Refrigerator Securement

Bulletin Type:	TSB	Publication Date:	April 2026
Bulletin #(s):	26-012	Make(s):	Jayco
Job Code(s):	9801651	Model(s):	Eagle FW
Flat Rate(s):	9801651 – .50 HR –Refrigerator Securement	Model Year(s):	2026

Incident:	Refrigerator is coming loose
Affected Units:	2026 Jayco Eagle FW
Parts Kit: 26-012JT	Parts Kit #: 26-012JT
	1 Qty - TUBE,STL 1.00X1.00X74.19 14GA BLK SLO FL SPRT 4 Qty - SCREW,#10X1.00 TRUSS OCTA DRIVE TYPE A G2 3 Qty - SCREW,RW QUAD 8.00X2.00 .67 BLK OXD
Misc. Tools & Supplies:	Screw gun
Parts Return Information:	N/A

Fig. 1

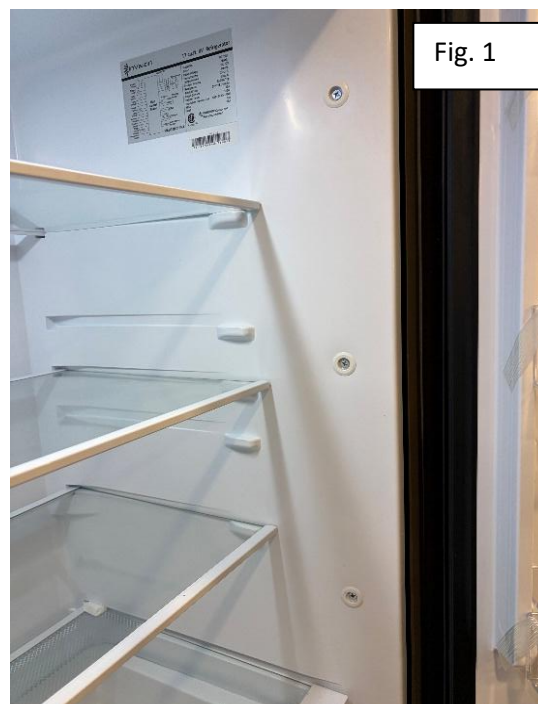
1. Remove the six screws (three on each side) from within the refrigerator as shown in figure 1.
 - a. Save the six screws for reinstalment

Fig. 2

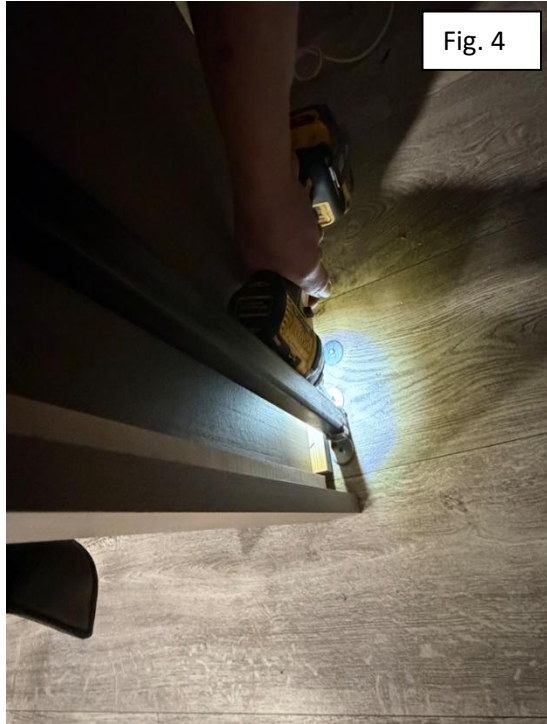
2. Pull the refrigerator out so you can get behind to install the steel brace as shown in figure 2.
3. Secure the steel brace with seven screws. Two 1" screws at the bottom into the floor and two 1" screws into the top of the cabinet, and then three 2" screws in the wood frame near the top. (Figures 3-5)

4. Push the refrigerator back into the cabinet space. Resecure the refrigerator with the six screws and make sure the refrigerator is even with the face of the cabinet.
